Bulletin # BU-4630

SAFETY BULLETIN

Ride Name: StarTrooper

Abstract of Issue: StarTrooper Lightning Bolt Sweep Light Cans.

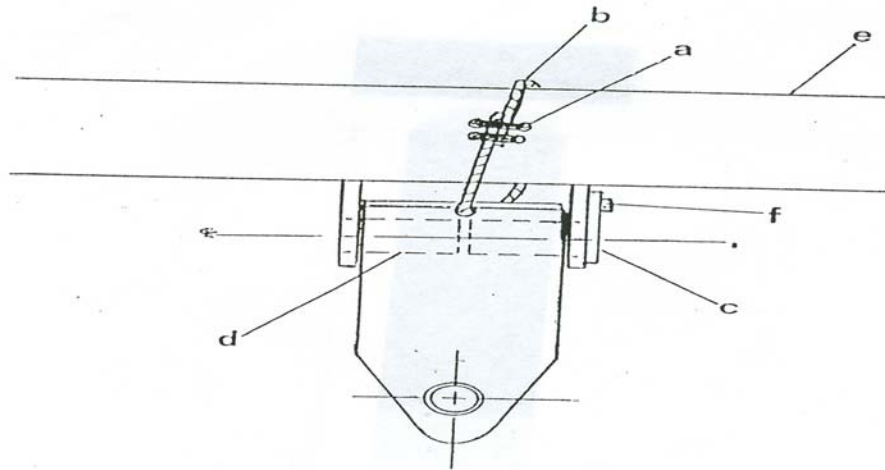
Reason for release: Because of a combination of factors, among them rough road conditions, one area of the StarTrooper lightning bolt sweep light cans is receiving a higher degree of stress than was expected. This can result in the partial failure of the welded joints, which could cause a lightning bolt to come off the ride during transportation or operation

Action to be taken: Dartron Industries, Inc requires that all StarTrooper's with serial #'s shown above inspect lightning bolt sweep light cans for structural cracks as shown in (fig 1). It is further recommended that all affected lightning bolt sweep light cans be reworked with the following reinforcement kit for added rigidity.

Parts required:

12	Gussets	5 3/8 x 13	#4630A
12	Gussets	4 5/8 x 13	#4630B
12	Gussets	3 3/4 x 6	#4630C
240	3/8 x 1 1/4	Hex Head Cap Screws	
264	3/8	Lock washers	
240	3/8	Nuts	
24	3/8 x 3/4	Hex Head Cap Screws	
540		Flat Washers
